Date: June 29, 2016
Prepared For: Rosemont Copper Company
By: Water & Earth Technologies, Inc.
Subject: Response to Technical Memorandum dated July 27, 2015 by Dr. Mathias Kondolf and James Ashby

Figure 1. Unit Discharge vs Watershed Area for Sonoita Creek from USGS Regression Equations.

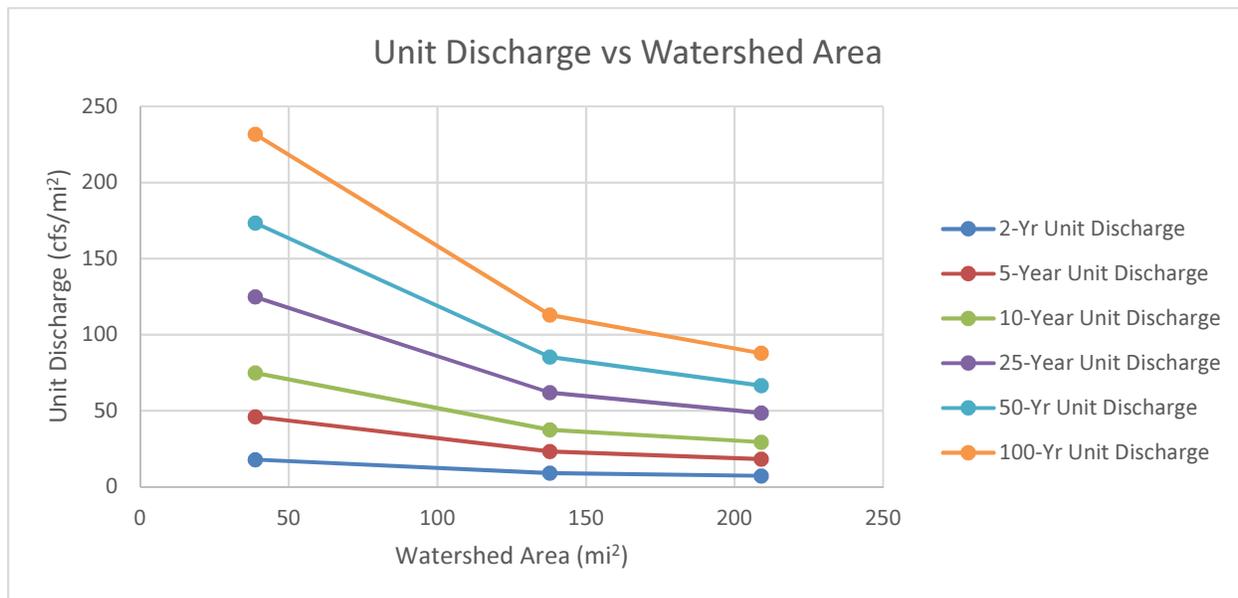
Finding 1: The hydrologic modeling significantly overestimates the water available for Sonoita Creek and the proposed constructed channels.

Kondolf-Ashby state that WET overestimates **peak discharge** for the project by 2-3 times, but their analysis clearly illustrates that **the ratio of peak discharge to watershed area** at the project is roughly 2-3 times larger than the **ratio of peak discharge to watershed area** at the USGS Patagonia gage located about 7 miles downstream of the project, and infer that discharge increases linearly with watershed area. However, literature and hydrologic models demonstrate that discharge does not increase linearly with watershed area for medium to large watersheds (such as this project) in the arid southwest. In fact, a recent EPA technical report (Levick et al., 2008), which was co-authored by Robert Leidy of the EPA, notes this relationship and references several papers that demonstrate the non-linear relationship between discharge and watershed area. The non-linear relationship results from three factors: spatial and temporal variability of monsoonal precipitation, transmission losses, and flow attenuation. Further analysis of this can be done by considering the USGS regional regression equations for estimating discharge in ephemeral streams in Arizona (Paretti et al., 2014). The USGS has subdivided Arizona into 5 flood districts based on their basin characteristics and rainfall-runoff response. Sonoita Creek is located in Flood Region 5. Discharge was calculated with the applicable USGS regional regression equation for the three sites used in the Kondolf-Ashby memo, and then discharge from each site was divided by watershed area to illustrate the non-linear relationship discharge has with watershed area (Table 1 & Figure 1).

Unit discharges from the USGS Regression Equations also demonstrate that the ratio of discharge to watershed area at the project is roughly 2-3 times larger than the ratio of discharge to watershed area at the USGS Patagonia Gage.
